RESPONSES TO PLANT SPECIFIC QUESTIONS ON DEPRESSURIZATION AND
DECAY HEAT REMOVAL
(QUESTIONS 6a, 6b, 12, 13a, 13c and 13d)

SAN ONOFRE NUCLEAR GENERATING STATION
UNITS 2 AND 3

JUNE 1983

**TUBE WALL THINNING
ACCEPTANCE CRITERIA**

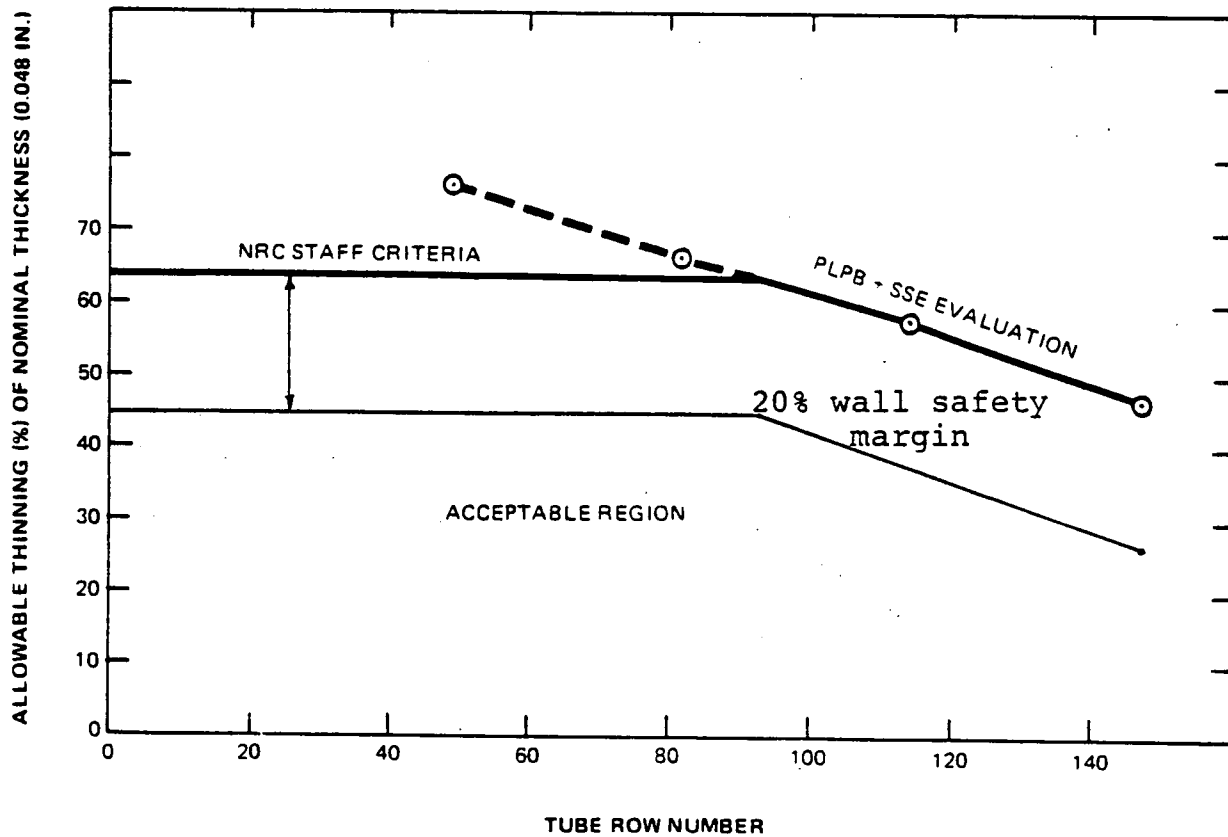
- a. What is the minimum allowable wall thinning that could exist in the steam generator tubes without plugging?
- c. Given a steam generator with the maximum allowed tube thinning and degradation, confirm that those tubes will maintain their integrity by demonstrating they have been analyzed and shown to

remain intact for all design basis loadings used for the steam generator design including seismic loads.

- d. Describe the analytical and experimental justification for establishing a minimum acceptable steam generator tube wall thickness for the CE System 80 steam generators in accordance with guidelines in Regulatory Guide 1.121. "Bases for Plugging Degraded PWR Steam Generator Tubes". The justification should include the analyses to calculate the hydraulically induced loading on the steam generator and the thermal response of its tubes and shell to an assumed LOCA, MSLB and an FWLB.

When evaluating against the above criteria for San Onofre steam generator geometry and operating conditions, an allowable tube thinning as shown in the upper curve of Figure 1 is permissible. However, the technical specification is conservatively set at a 20% lower tube wall thinning value.

In summary, the design basis can be met for a design base earthquake in conjunction with either a primary loop pipe break (PLPB) or a main steam line break (MSLB), with appreciable tube wall thinning. The actual allowable thinning being related to tube row can be as high as 64% wall penetration for rows 1-91 and decreasing linearly to 47% wall penetration at row 147. If it is determined during surveillance testing that tube wall thinning may approach 20% of the value shown in Figure 1 during the next operating cycle, the tubes will be removed from service by plugging to ensure that the thinning criteria will not be violated.

Figure 1

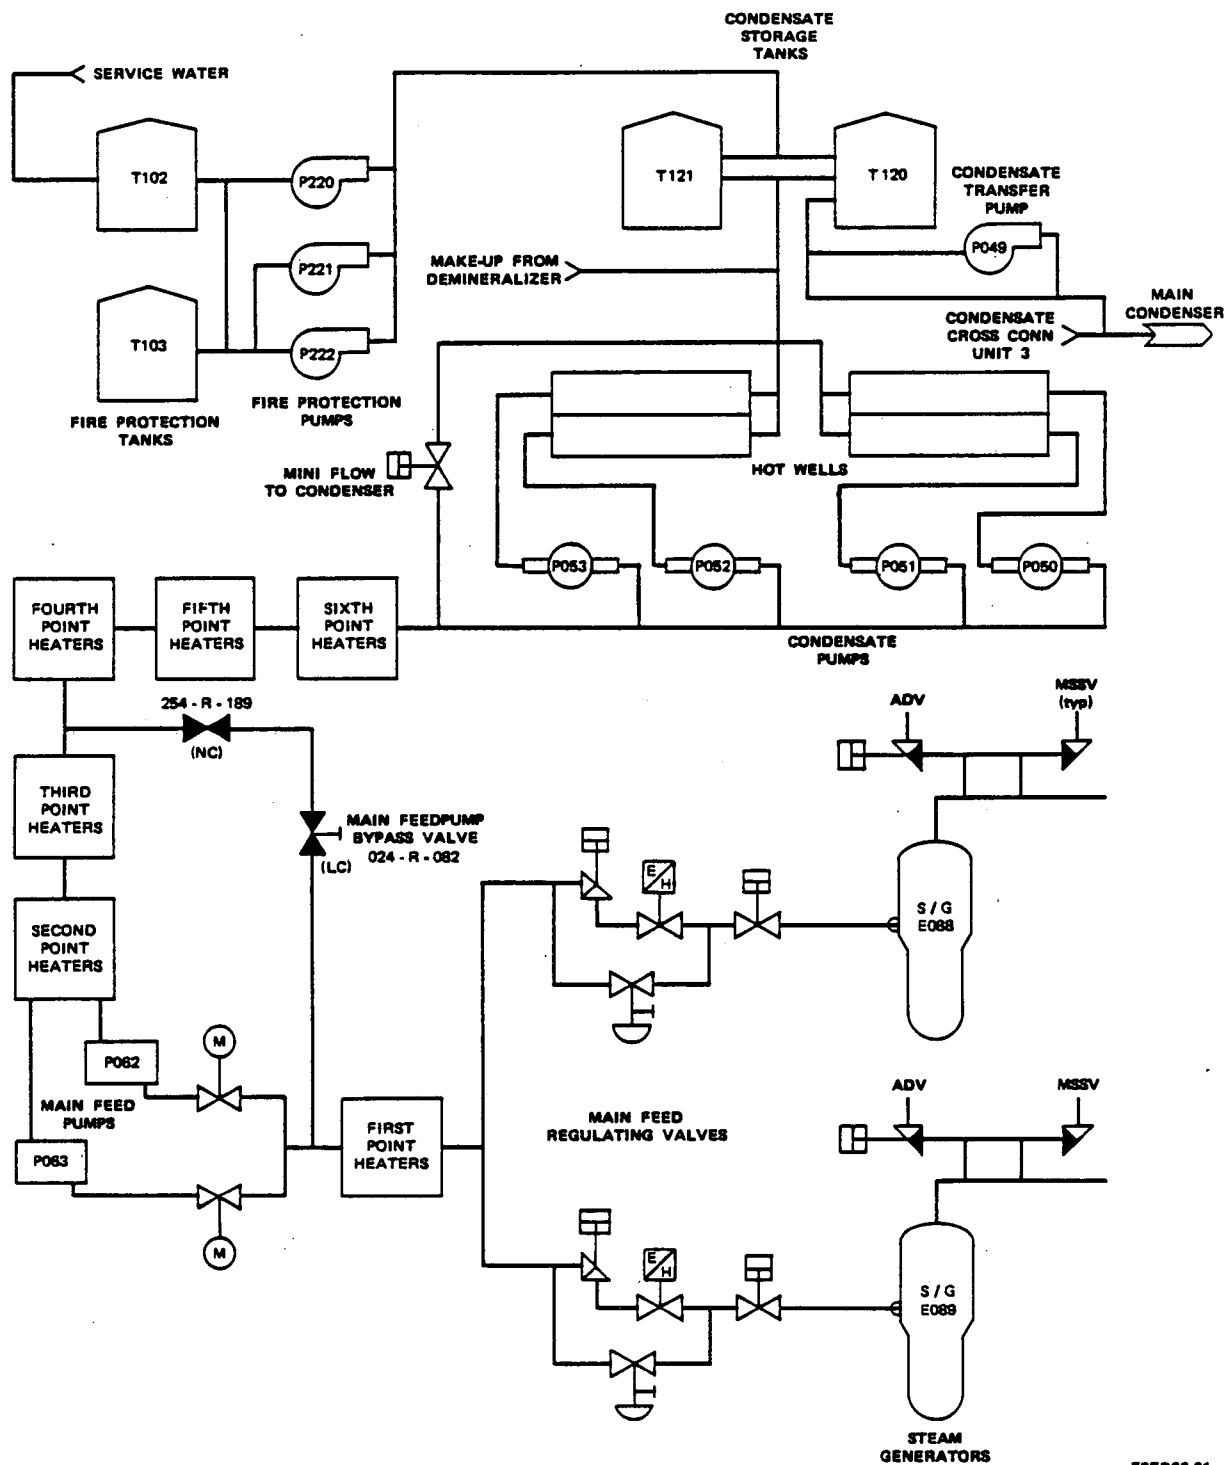
Describe the proposed low pressure system to supplement the AFWS and its use, including water supplies (and their capacity), flow paths, pumps, power supplies to components, control equipment and procedures.

In the unlikely event of a loss of the safety grade three train AFWS at SONGS 2 & 3, there are several sources of low pressure water available for use as makeup to the steam generators (see Figure 1). The preferred source would be the condensate system of the affected unit. The four condensate pumps are relatively high head (500-600 PSIG) and can use water from multiple sources (e.g., hotwell, condensate storage tanks, demineralizer make up) and through use of the feed pump bypass line, deliver make-up directly to each steam generator. Each condensate pump has a capacity of 7750 GPM. The normal condensate make-up sources (hotwell and condensate storage tanks) contain 746,600 gallons. If additional make up is required, there are several alternate means to refill the condensate storage tanks. Make up grade water is available from the condensate system of the companion unit through the condensate cross tie line and from the onsite demineralizer system. As a back up to these sources, service grade water is available from the fire protection system of Units 2 & 3 as well as Unit 1. The fire protection reserve for Units 2 & 3 is 750,000 gallons and Unit 1 has a 3 million gallon reservoir.* This means that there is over 5 million gallons of on-site condensate make up water for the SONGS 2 & 3 steam generators to supplement the AFWS. There is also a virtually unlimited supply of potable water available from the domestic water system (Tri-Cities Municipal Water District).

The alignment of the condensate pumps to the steam generator can be completed from the control room with the exception of opening the two main feed pump bypass valves which can be accomplished by local manual operator action. All other operations, including control of steam generator pressure and water level, are completed following existing SONGS 2 and 3 procedures. Refer to Figure 1 for a schematic of the alternate secondary heat removal configuration.

**TUBE WALL THINNING
ACCEPTANCE CRITERIA**

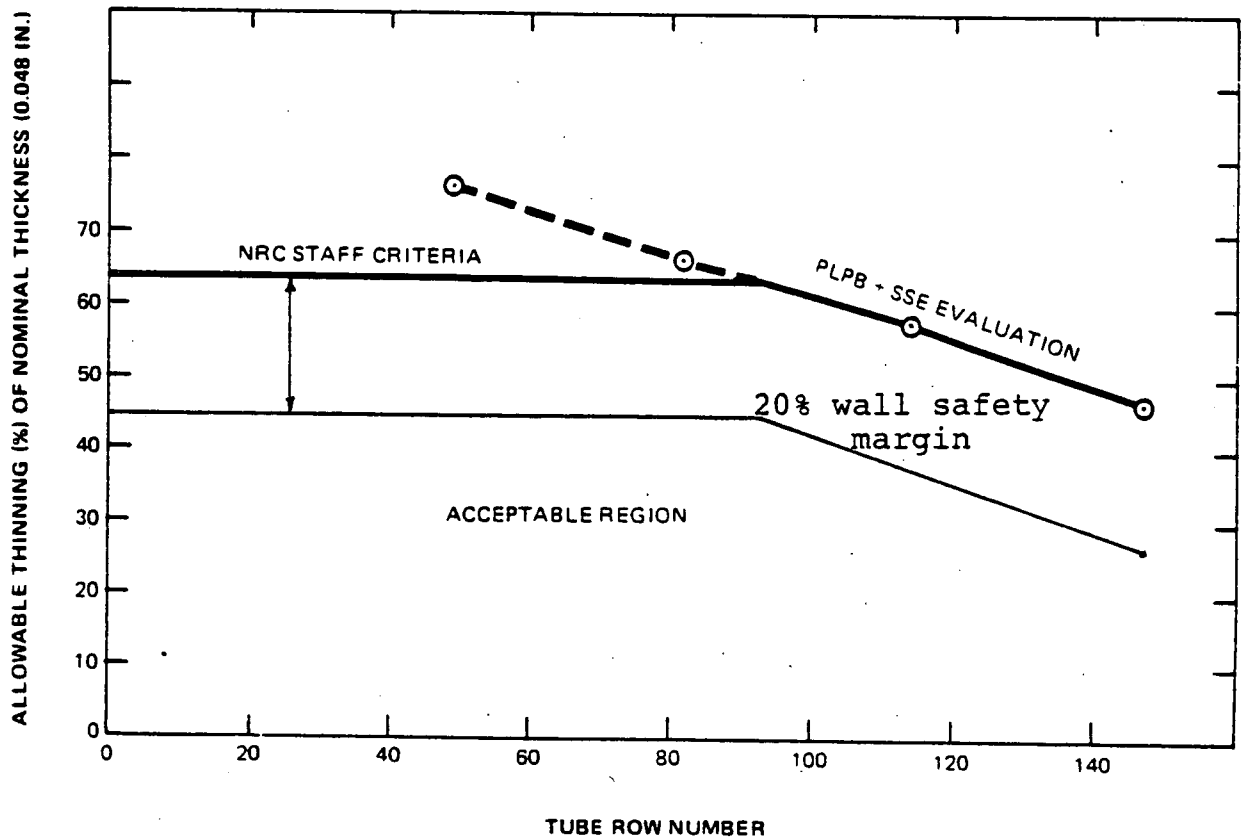
- a. What is the minimum allowable wall thinning that could exist in the steam generator tubes without plugging?
- c. Given a steam generator with the maximum allowed tube thinning and degradation, confirm that those tubes will maintain their integrity by demonstrating they have been analyzed and shown to remain intact for all design basis loadings used for the steam generator design including seismic loads.
- d. Describe the analytical and experimental justification for establishing a minimum acceptable steam generator tube wall thickness for the CE System 80 steam generators in accordance with guidelines in Regulatory Guide 1.121. "Bases for Plugging Degraded PWR Steam Generator Tubes". The justification should include the analyses to calculate the hydraulically induced loading on the steam generator and the thermal response of its tubes and shell to an assumed LOCA, MSLB and an FWLB.

Figure 1 shows the curve for acceptable tube wall degradation using absolute NRC criteria in addition to a curve utilizing a 20% safety factor to account for flaw detectability and degradation between inspections.

When evaluating against the above criteria for San Onofre steam generator geometry and operating conditions, an allowable tube thinning as shown in the upper curve of Figure 1 is permissible. However, the technical specification is conservatively set at 20% lower tube wall thinning value.

In summary, the design basis can be met for a DBE in conjunction with either a PLPB or MSLB, with appreciable tube wall thinning. The actual allowable thinning being related to tube row can be as high as 64% wall penetration for rows 1-91 and decreasing

linearly to 47% wall penetration at row 147. As an additional safety factor, if it is determined during surveillance testing tube wall thinning may approach 20% of the value shown in Figure 1 prior to the next operation cycle, the tubes will be removed from service by plugging.
